# RENESAS TECHNICAL UPDATE

Product Category	MPU/MCU		Document No.	TN-SH7-A818A/E	Rev.	1.00
Title	The error correction and addition about LCD controller (LCDC)		Information Category	Technical Notification		
Applicable Product	SH7760 Group	Lot No.	Reference Document	SH7760 Group Hardware Manual Rev.2.00 Feb. 12, 2010 (REJ09B0554-0200)		
		All lots

Figure 30.4 Flowchart for Power-Supply Control Sequences

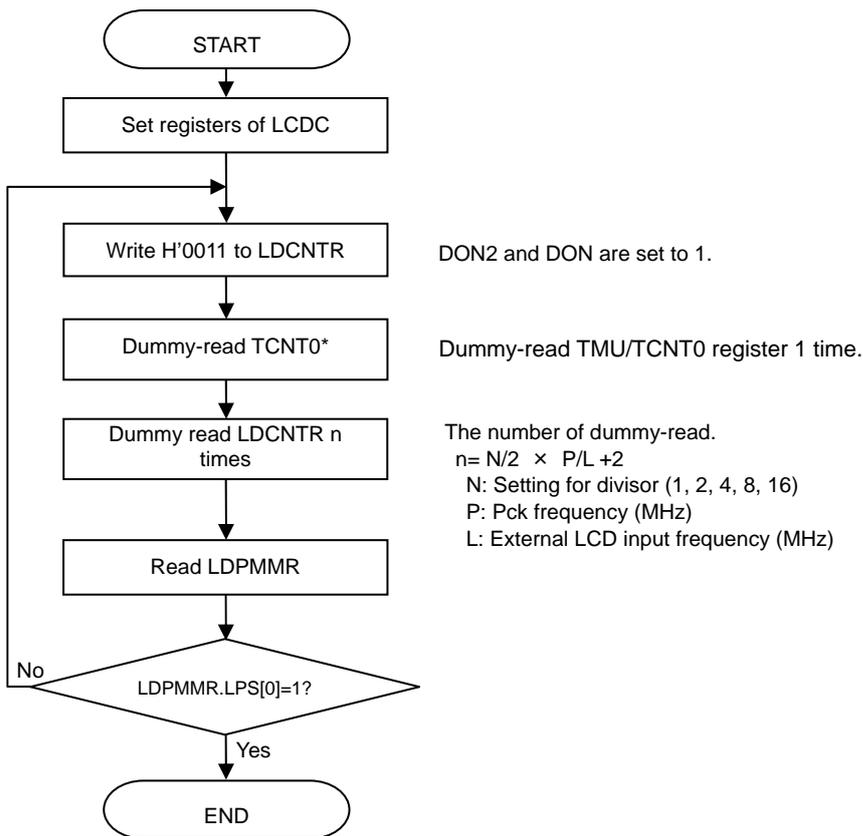
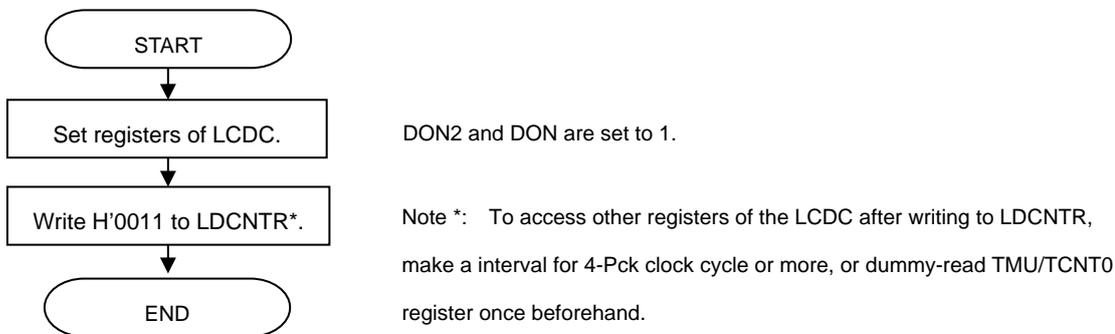
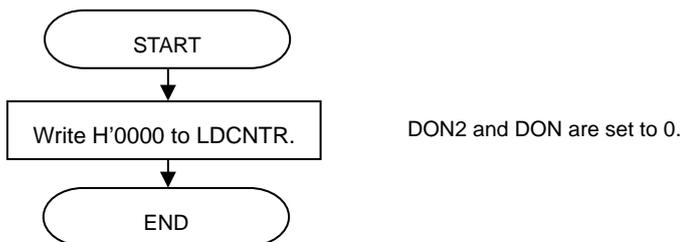
## 2. Added Figure 30.4

Figure 30.4 to 30.22 are re-numbered to Figure 30.5 to 30.23 respectively, then add new Figure 30.4.

(1) Power-on sequence (when LCD\_CLK is selected as the input clock)

(2) Power-on sequence (when the peripheral clock or bus clock is selected as the input clock)

(3) Power-off sequence
